HORSHAM DISTRICT COUNCIL CONSULTATION

TO:	Horsham District Council – Planning Dept
LOCATION:	Land Off Platts Roundabout Newbridge Road Billingshurst West Sussex
DESCRIPTION:	Variation of condition 1 of previously approved application reference DC/19/0295 (Hybrid application for the erection of petrol filling station with convenience store and sandwich bar, car wash, jet wash and car parking; motorcycle showroom and workshop with associated car parking; outline planning permission for flexible employment space (B1b/B1c/B2/B8) totalling 4,627sqm with associated car parking and circulation space (scale, landscaping and appearance reserved); new access to the site from A272 and pedestrian link to footbridge over A29.) To increase size of building for the provision of additional display space. Two car park spaces revised to electric charging spaces.
REFERENCE:	DC/23/1892
RECOMMENDATION:	Advice / No Objection / Objection / More Information / Modification / Refusal

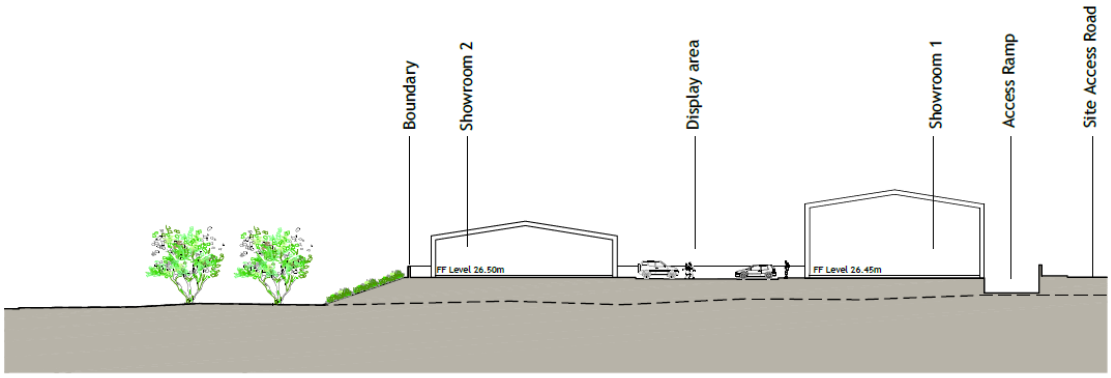
To understand the impacts of the additional bulk of showroom 1 and higher ridge height of showroom 2 (if this is the case), it is recommended that a photomontage for viewpoint 7 (LVA) is provided and the assessment updated.

It is appreciated the principle of development is established, but this will help to understand the level of adverse effects and if mitigation (i.e reduction of ridge height or lowering of the buildings are necessary).

SECTION A-A

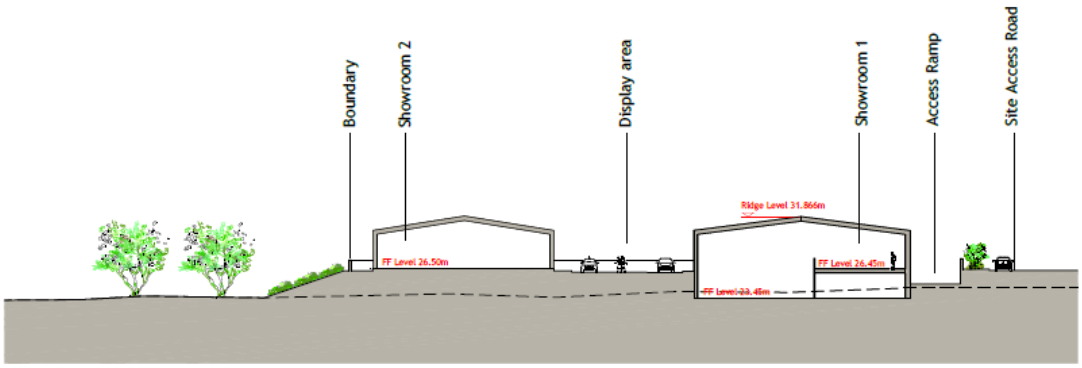
The proposed and approved section have inconsistent information and I'm not clear if the ridge of showroom 2 is now being raised to approx. 31.866 as showroom 1?

FF for both buildings seem to remain as approved and levels within the key plan remain the same but when looking at the section, the ridge level of showroom 2 is now at the same height as showroom 1 and the latter seems to be remain as 31.866.

There are also inconsistencies with proposed and approved levels varying between showroom proposed elevations plans and indicative site section.

On the face of it, the proposed section seems to show showroom 1 at a lower levels but when looking at the detail this is not the case.

Clarification is needed as to any changes pertinent to ridge height of showroom 2 as this is likely to exacerbate views of the site from the more sensitive receptors of prow 1327.
